CFC Percy St. Auburn

13 Percy Street, Auburn, NSW 2144

S4.55 - AMENDMENT LIST

ISSUE FOR S4.55

Drawing Number: 11250_DA002 Issue: E

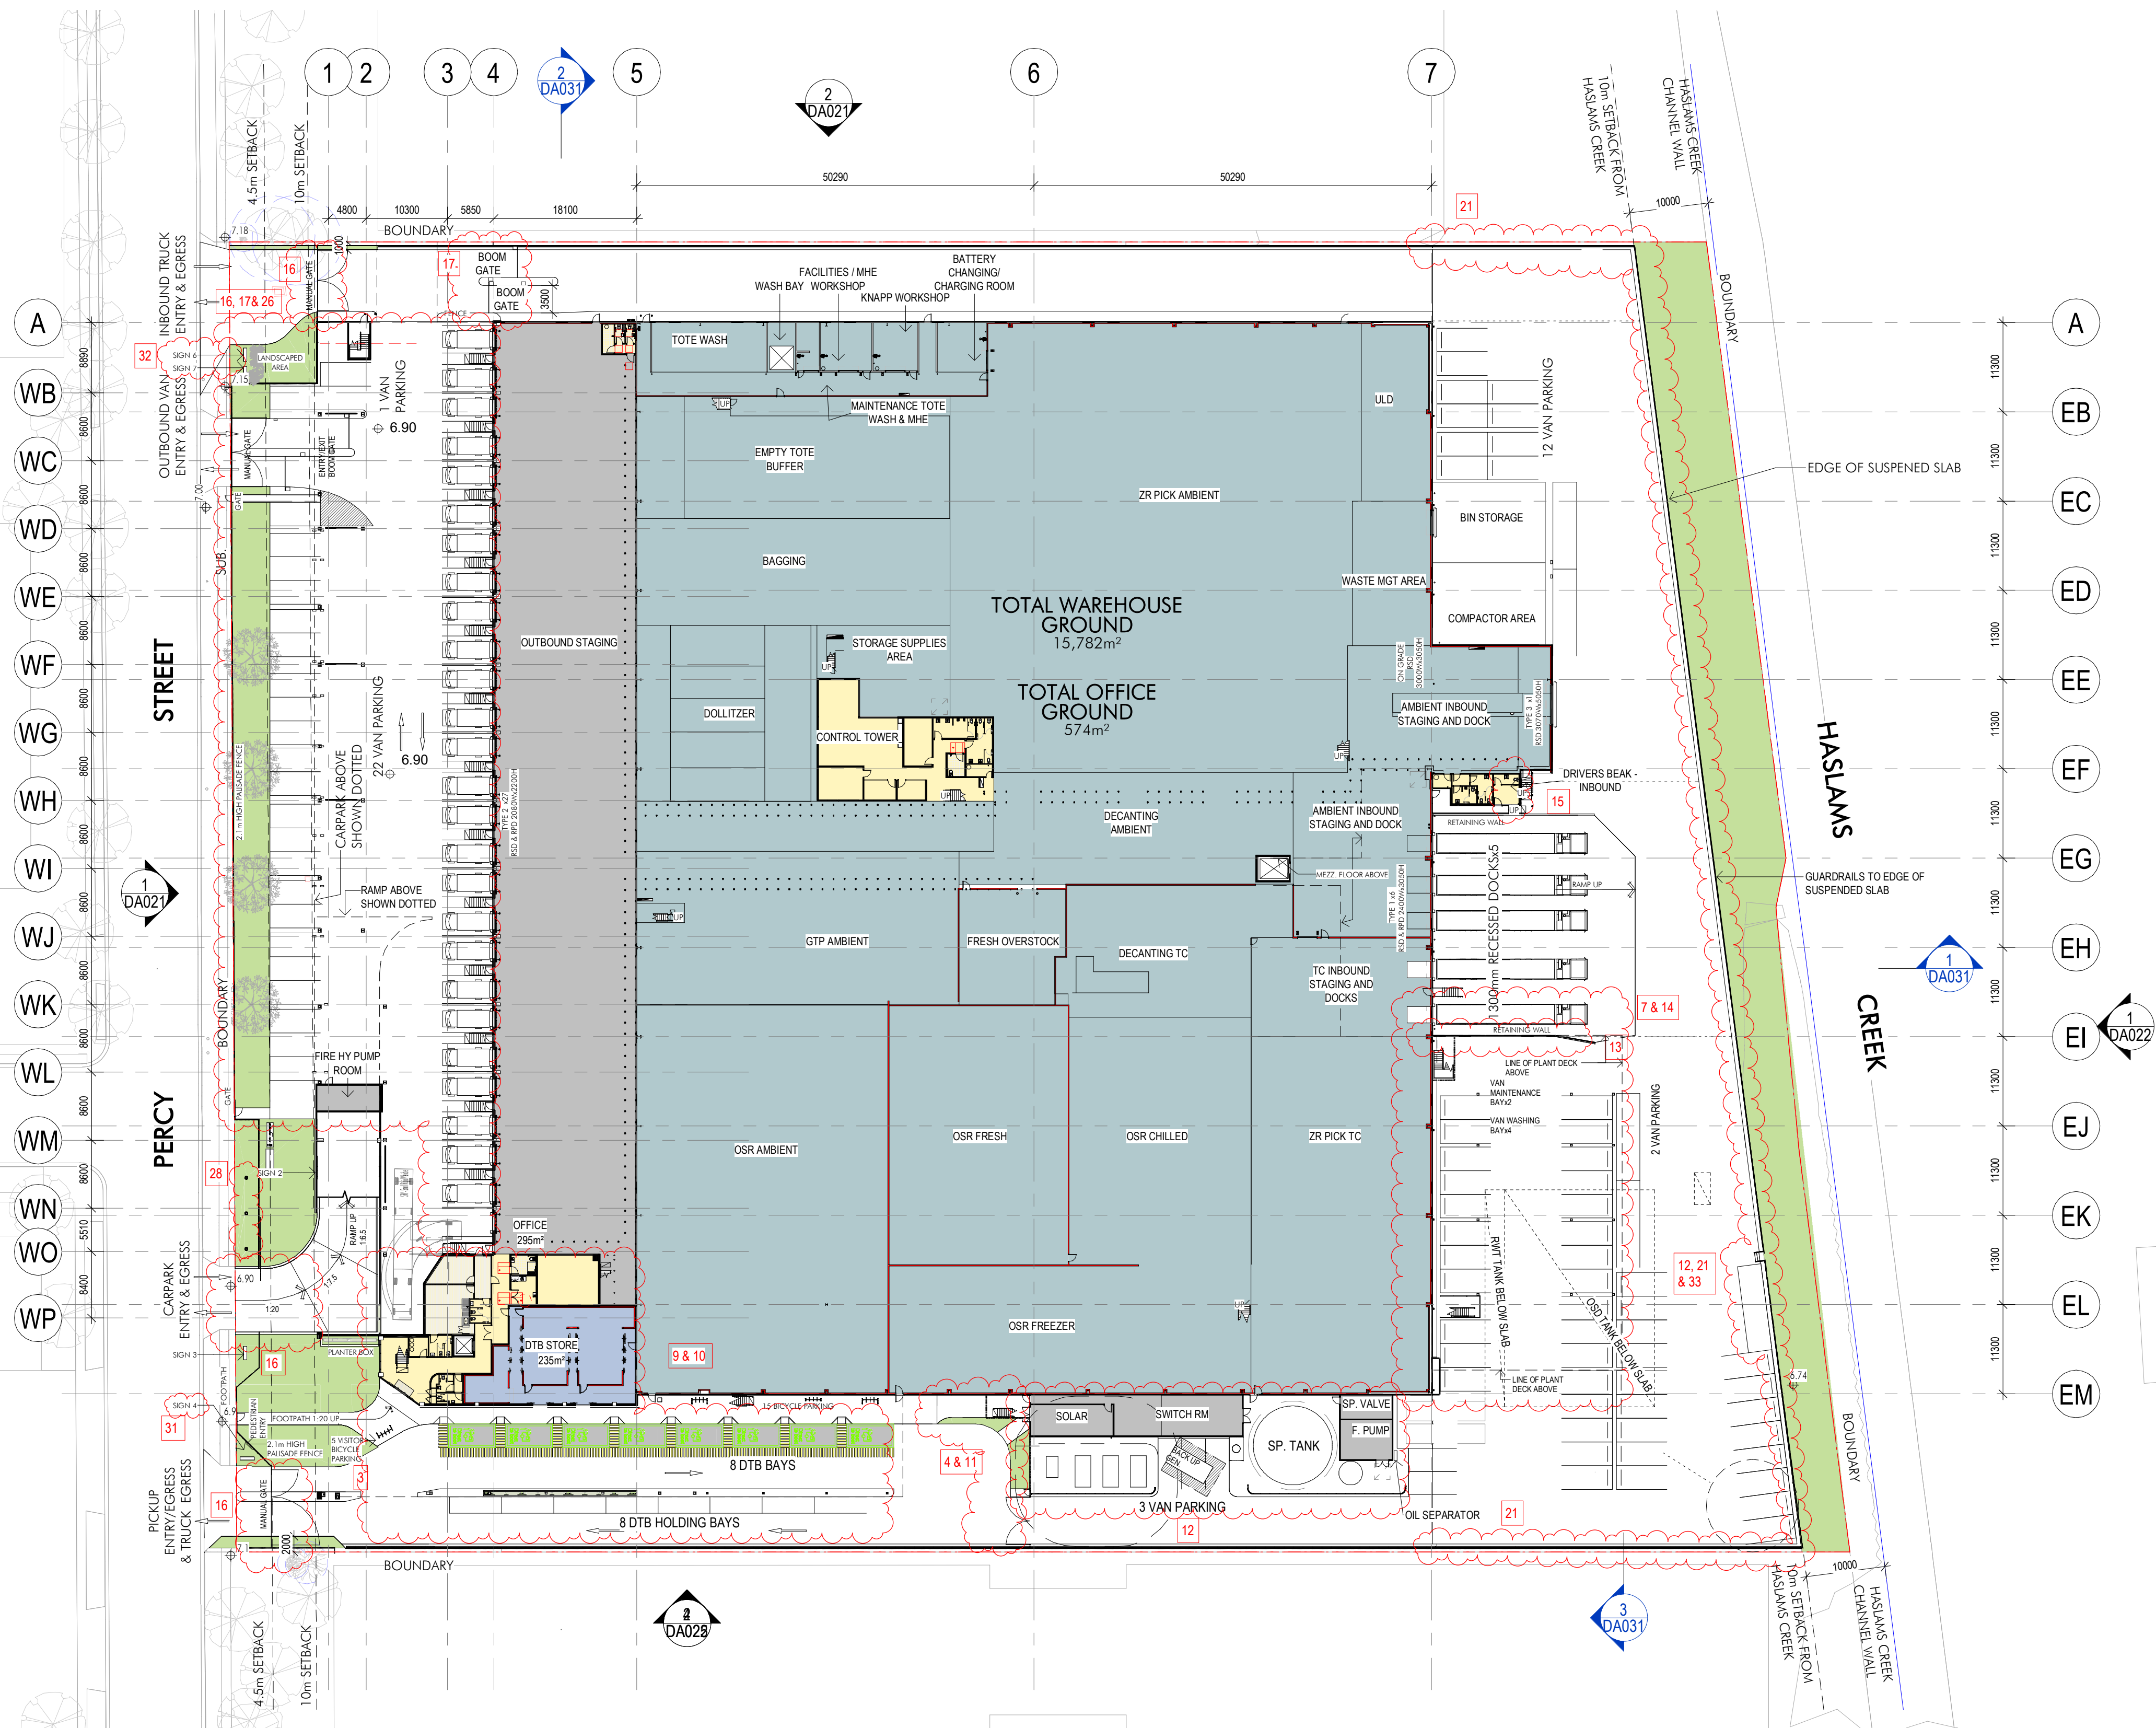
- Carpark layout change due to additional mech.plant rooms & boomgate
- Extension of roof over L1 office entry
- Added external egress stair, awning over DTB bays and plant deck

- Added external egress stair to access mezz. floors and roof
- Added mech. exhaust & plant on roof & removed translucent roof sheets
- Inbound dock awning is reduced

- Added mech & refrigeration plant rooms on rear elevated plant deck, and associated egress stair
- Added removal of existing concrete channel in demolition

- Additional DTB store and DTB bays, including changed configuration of DTB bays
- Office internal layout amended
- Added landscape area, aluminium screen & gates

- Southern plant area layout changed as following
 - Solar and switch room layout reconfigured
 - Sub & HVC updated
 - Permanent generator reduced to single large gen. Portable gen is added

- Diesel tank is added for backup generators
 - Armoo is added around sub & sprinkler plant area
 - One (1) van parking relocated
- Precast wall is erected higher to support the rear elevated plant deck

Drawing Title:
Ground Floor Plan

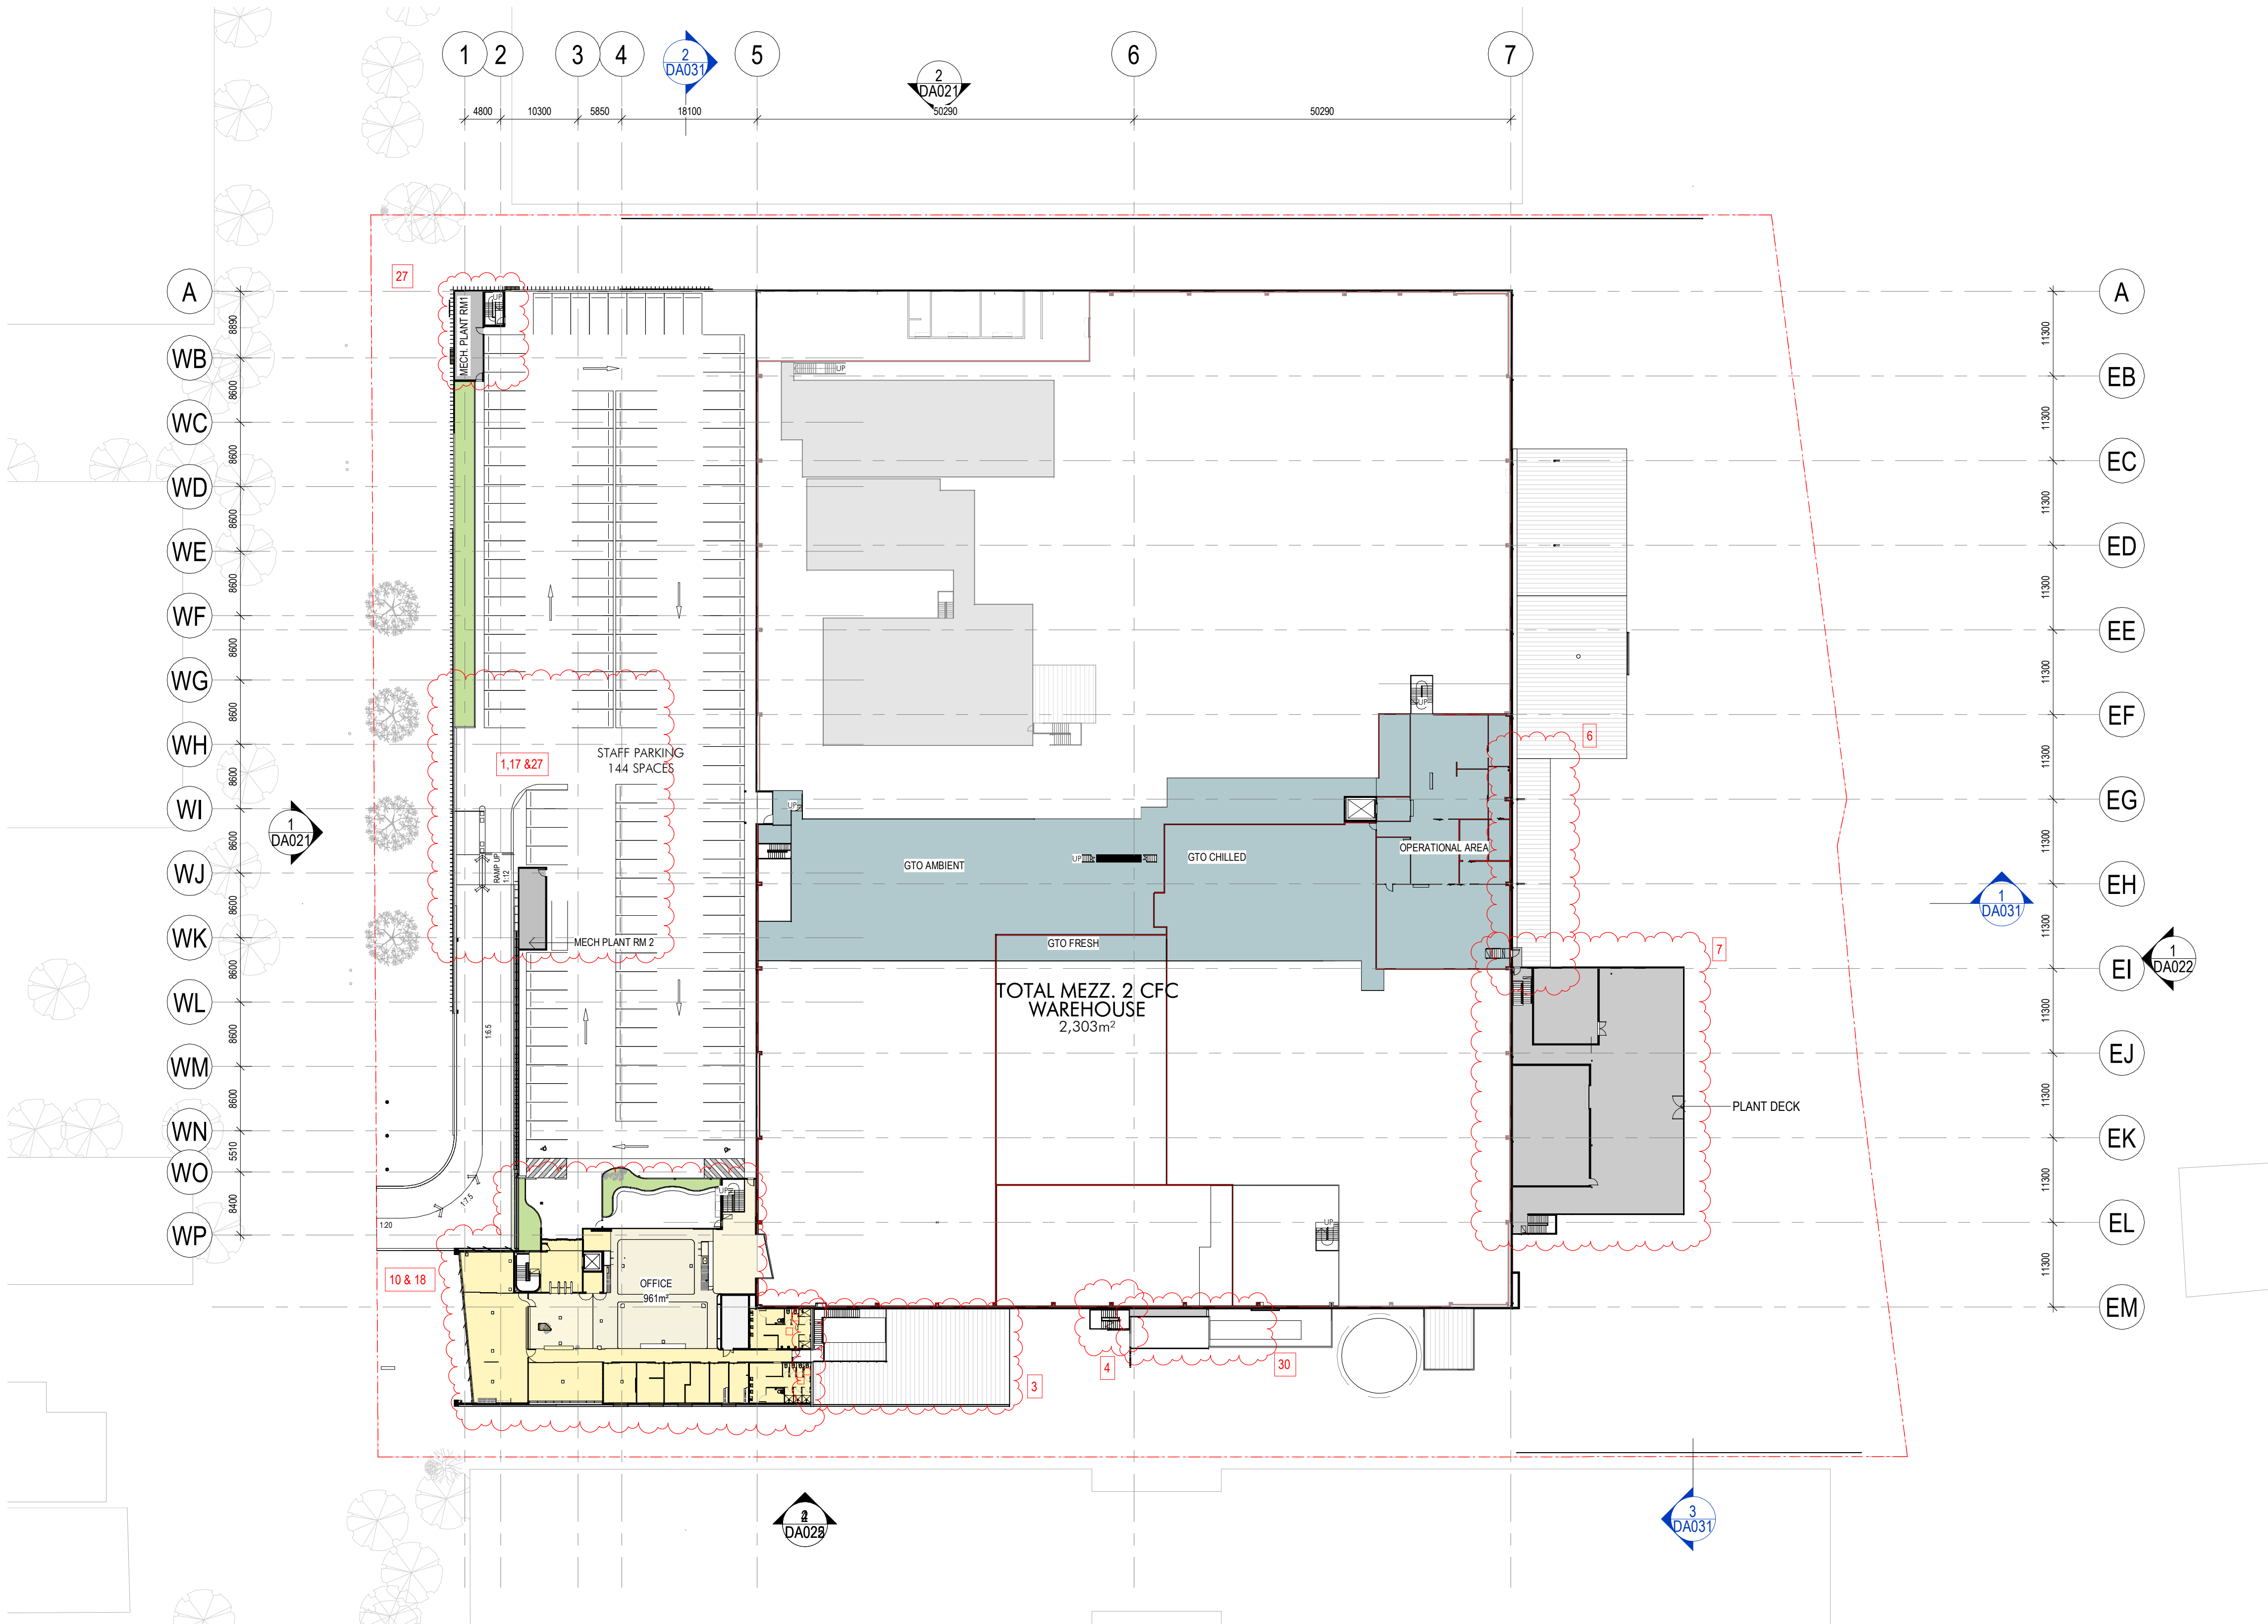
- Carpark layout change due to additional mech.plant rooms & boomgate
- Extension of roof over L1 office entry
- Added external egress stair, awning over DTB bays and plant deck

- Added external egress stair to access mezz. floors and roof
- Added mech. exhaust & plant on roof & removed translucent roof sheets
- Inbound dock awning is reduced

- Added mech & refrigeration plant rooms on rear elevated plant deck, and associated egress stair
- Added removal of existing concrete channel in demolition

- Additional DTB store and DTB bays, including changed configuration of DTB bays
- Office internal layout amended
- Added landscape area, aluminium screen & gates

- Southern plant area layout changed as following
 - Solar and switch room layout reconfigured
 - Sub & HVC updated
 - Permanent generator reduced to single large gen. Portable gen is added

- Diesel tank is added for backup generators
 - Armco is added around sub & sprinkler plant area
 - One (1) van parking relocated
- Precast wall is erected higher to support the rear elevated plant deck

- Maintenance and wash bays are added
- Added an external stair to inbound dock area
- Security gates added
- Boom gates added
- Minor enlarged L1 office lobby & additional stair next to rec area

- NOT USED
- Mech. Louvre added
- Heavy duty guardrail added to suspended slab edges
- Replaced transparent wall sheeting to Longline metal cladding
- Pickup graphic extended

- CFC sheeting is removed from Office ground elevation
- NOT USED
- Outbound Loading dock size & Van parking size increased (TBC)
- Two mechanical plant rooms on carpark level added

- Added 3 flag poles
- Added 2 lightning poles
- Added generator on slab above switch and solar rooms
- Sign 03 & Sign 04 amended
- Two (2) signs (Sign 06 & Sign 07) added

- South-east stair relocated
